Service Information Sheet No. 11

CLUTCH ADJUSTMENT

The M.G. Car Company Ltd.

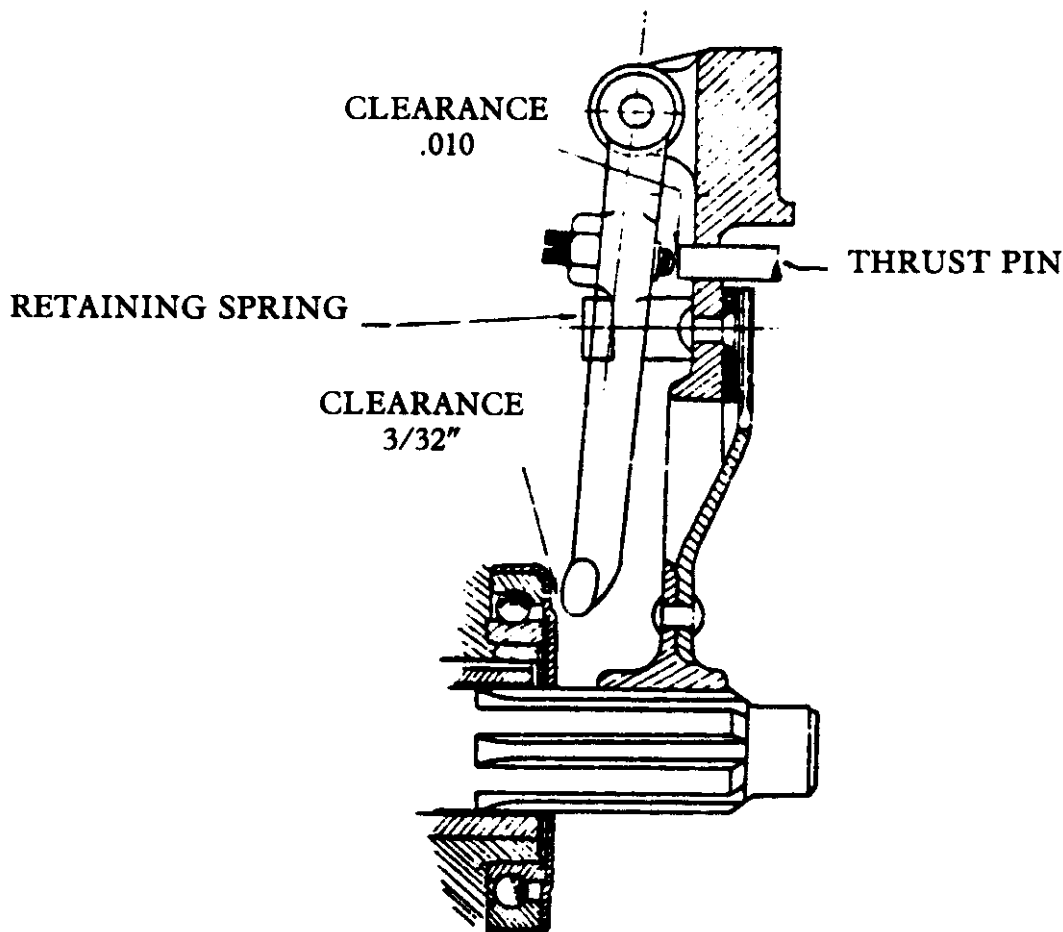
It has been thought advisable to issue information regarding clutch adjustment as cases have come to our notice where incorrect adjustment has caused excessive wear to the clutch fingers. The first adjustment is between the clutch fingers and the clutch thrust race. The clearance should be measured by a gauge $3/32$ in. thick (see drawing), care being taken to get the same clearance for each finger.

The second adjustment, which is equally important, concerns the amount of movement the clutch fingers have between the retaining springs and clutch operating pins. The duty of the retaining springs is to prevent the fingers fouling the thrust race. These springs, therefore, should be set carefully to allow a $.010$ in. gauge to be inserted between the clutch adjusting screw and the clutch thrust pin, as indicated on the drawing.

FIG. 1
SHOWING POSITION OF
ECCENTRIC BUSHES FOR
J. MODELS

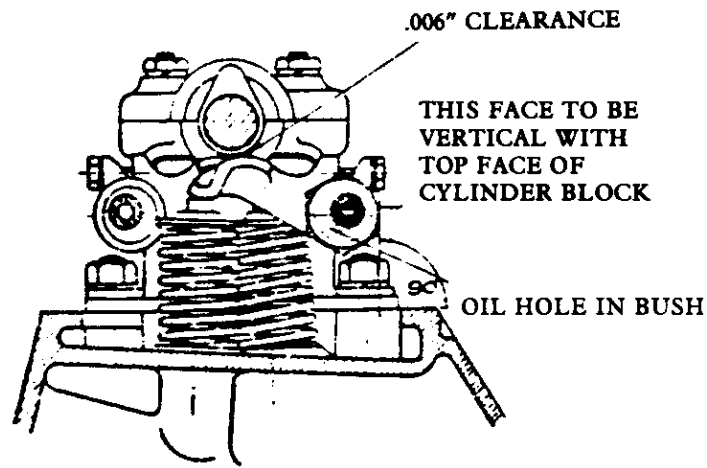
1. Set the rocker eccentric bush in the position shown in Fig. 1 for the J. Type and that as shown in Fig. 2 for the K., L., PA., N., KN. and PB. Type models.

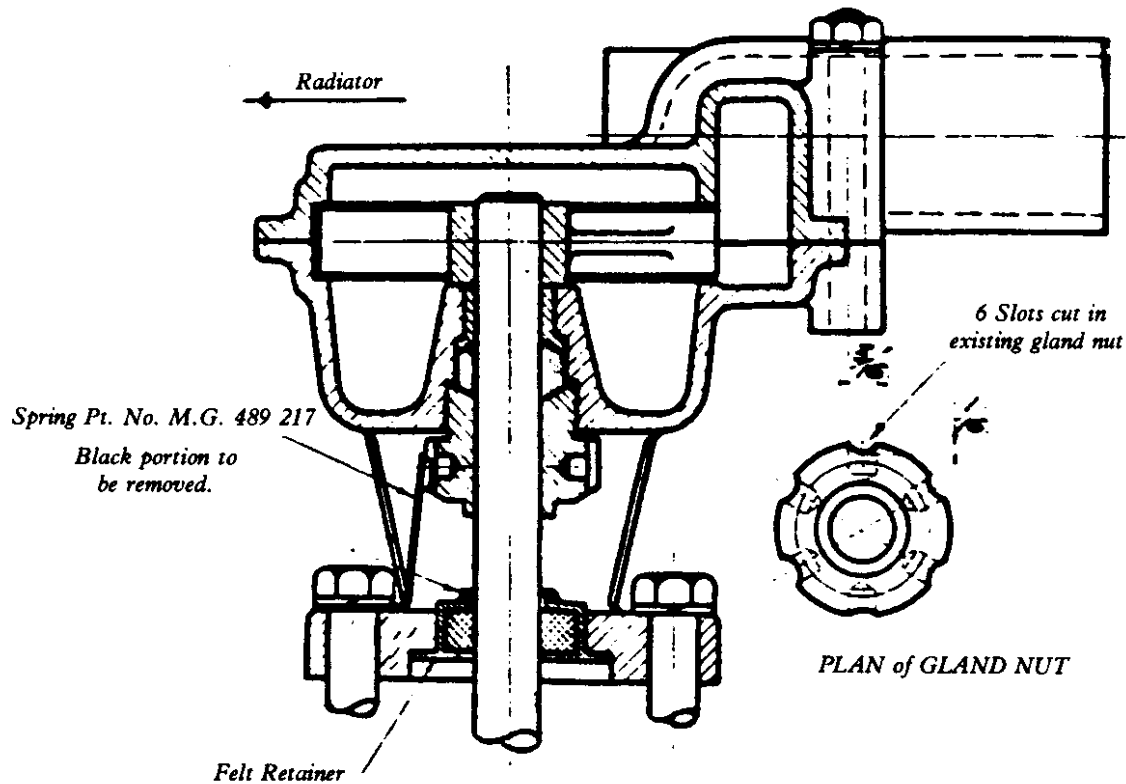
A new gland nut retaining spring has been designed to supercede the original type coil spring.

This spring is more positive in action and eliminates the possibility of water (which may leak past the gland) finding its way into the sump past the spindle sealing felt, owing to it being trapped by the coil spring.

The existing gland nut is slotted to receive the new spring.

The coil spring spigot is removed from the spindle felt retainer.

The new retaining spring is secured by means of the front set screw which secures the pump to the front bearing housing.

The water drain hole is increased from $\frac{1}{8}$ in. diameter to $\frac{5}{32}$ in. diam.

Supplies of the new spring, Part No. M.G. 489 217, can be obtained on application being made to our Service Stores Department. Price 9d. each (retail).
